Quick Fix Changes for PJM Manual 21A *Determination of Accredited UCAP Using Effective Load Carrying Capability Analysis*

March 08, 2022

“Section 5.2.1 Onshore Wind and Solar

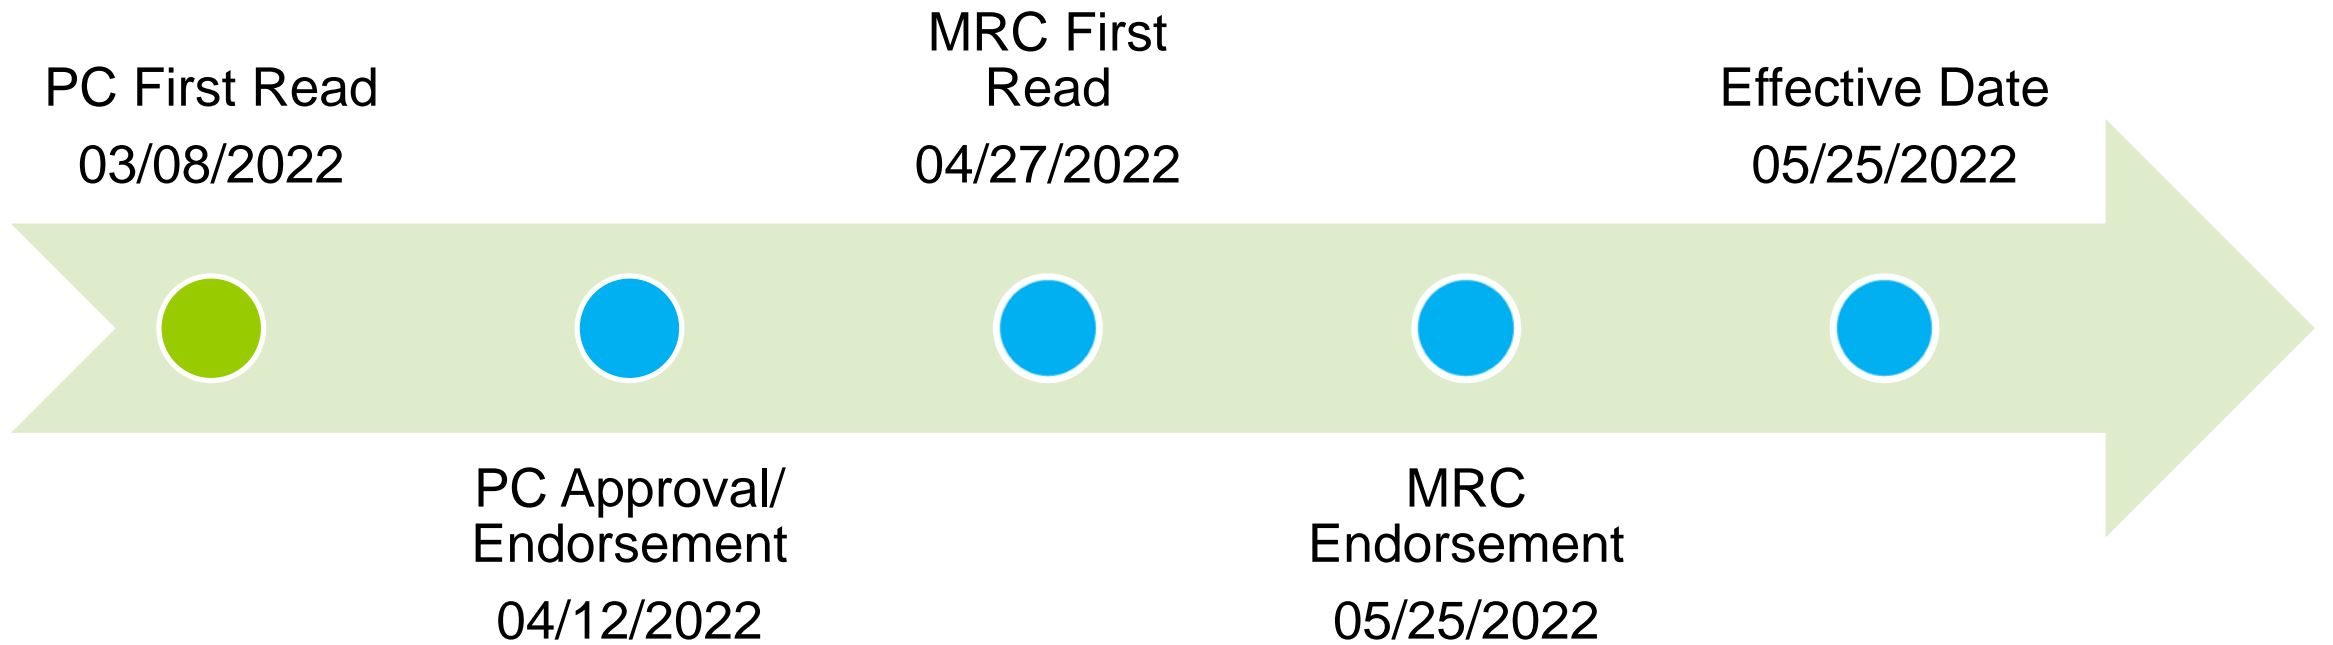
Remove language to allow the current voluntary process to continue beyond March 1, 2022:

~~Starting with ELCC data submission on or after March 1, 2022, providers of onshore wind and solar resources must provide the following data. Prior to March 1, 2022, providers~~
Providers of onshore wind and solar resources must provide the following data only if requesting a unit-specific backcast, otherwise they may provide it if desired.”
